## **Assembly Update 035**

## Title- Brake Disc Collar (Revision C)

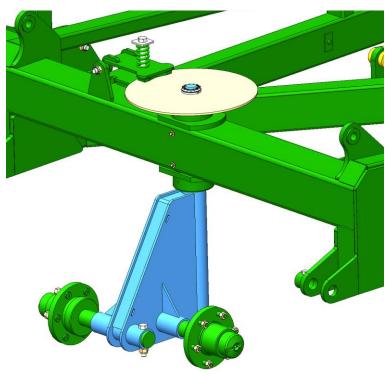
Ensure when unscrewing bolts to fit collar over that some thread is still engaged otherwise you will not be able to screw bolt in.

Slide collar over shaft and inside the brake disc hole.

Tighten in a cross pattern, Bring all bolts up equally to 17Nm (12.54 Ft/Lbs) (caution if a single bolt is done up to tension there is a risk of the bolt breaking)
